STATE OF CONNECTICUT
CONNECTICUT SITING COUNCIL

IN RE: :
 :
A PETITION OF WOODSTOCK SOLAR ONE, : PETITION NO. 1617
LLC AND VCP, LLC d/b/a VEROGY, LLC FOR A :
DECLARATORY RULING FOR THE PROPOSED :
CONSTRUCTION, MAINTENANCE AND :
OPERATION OF A 3.0 MW AC SOLAR :
PHOTOVOLTAIC ELECTRIC GENERATING :
FACILITY AT 11 CASTLE ROCK ROAD, :
WOODSTOCK, CONNECTICUT : JULY 15, 2024

**RESPONSES OF WOODSTOCK SOLAR ONE, LLC AND VCP, LLC
D/B/A VEROGY TO CONNECTICUT SITING COUNCIL INTERROGATORIES**

Public Water Supply Map

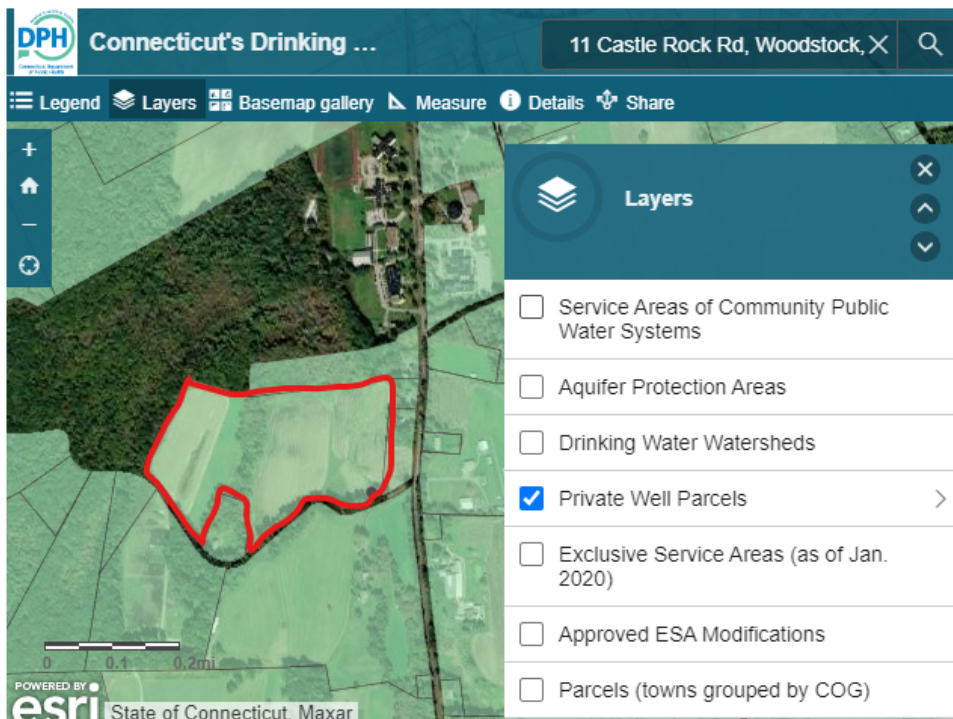
Are there any water supply wells in the vicinity of the site? If yes, would vibrations from the installation of racking posts affect well function and/or water quality, such as well water sedimentation?

A check of the Connecticut Department of Health's Public Water Supply Map (see below) indicates that the subject parcel and surrounding parcels to the south, east, & west are served by private wells. The parcel to the north (Woodstock Academy) is currently served by a Community Public Water System. Based on the depth of groundwater on site, depth to which the posts will be driven, and the relevant distance to these adjacent parcels, it is not anticipated that vibrations from post installation will affect well function and/or water quality.
